| Product / Process Change Notification (PCN) | |
| PCN Number: PCN_ConUSB2_20241219 Affected Series: WR-USB Affected Order Codes: 614004184726 614104184726 PCN Date: 2024-09-19 (YYYY-MM-DD) Effective Date: 2024-12-19 (YYYY-MM-DD) | Change Category: <input type="checkbox"/> Equipment/Location <input checked="" type="checkbox"/> General Data <input type="checkbox"/> Material <input type="checkbox"/> Process <input type="checkbox"/> Product Design <input type="checkbox"/> Shipping/Packaging <input type="checkbox"/> Supplier <input type="checkbox"/> Software |

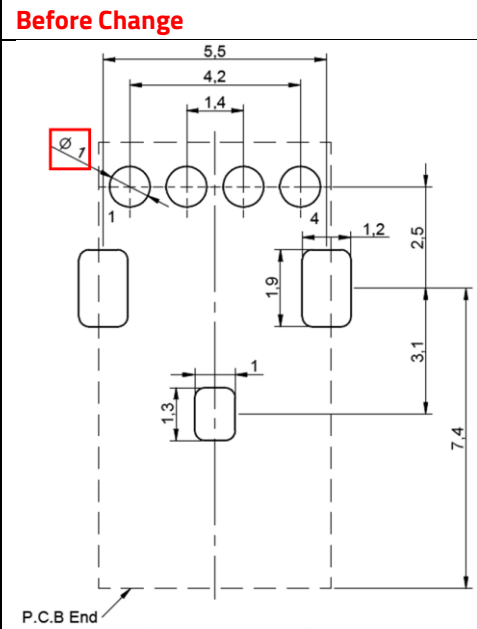
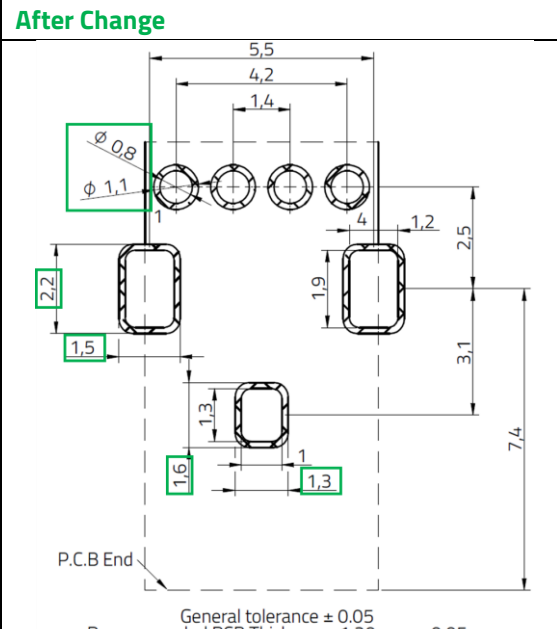
| Product / Process Change Notification (PCN) | |
|---|---|
| Description of Change: <p>To ensure an improved product assembly, Würth Elektronik eiSos will update the recommended layout to let visible the annular ring of the holes. This includes additional dimensions.</p> <p>This is a datasheet correction only. There will be no change in form, fit, function, quality or reliability of the product.</p> | |

| Details of Change: | | |
|--|---|---|
| 614004184726 |  <p>General tolerance ± 0.05</p> |  <p>General tolerance ± 0.05 Recommended PCB Thickness: 1.20 mm ± 0.05</p> |

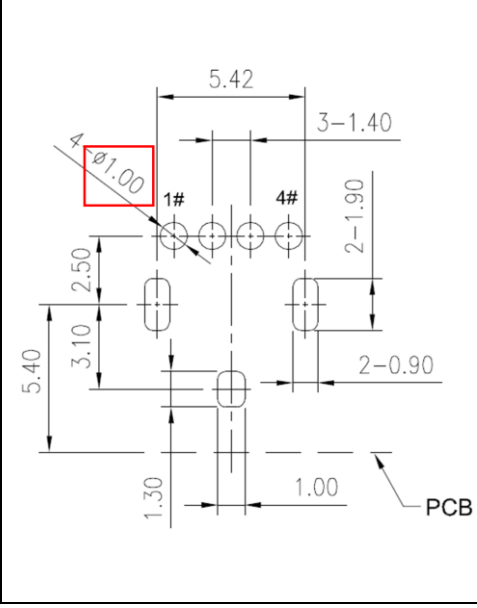
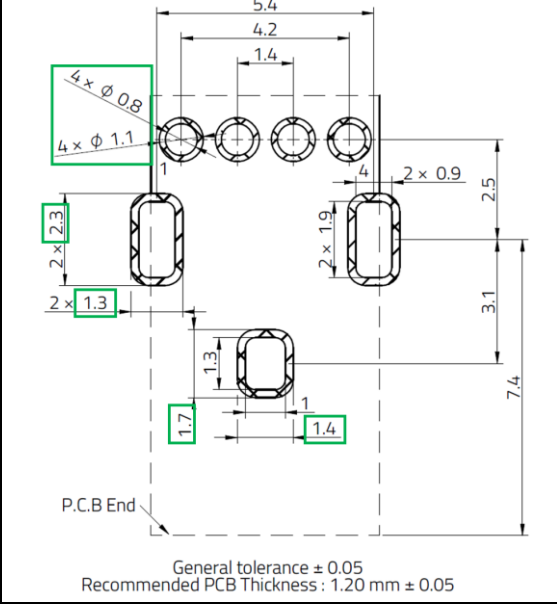
| Details of Change: | | |
|--|---|---|
| 614104184726 |  |  <p>General tolerance ± 0.05 Recommended PCB Thickness: 1.20 mm ± 0.05</p> |
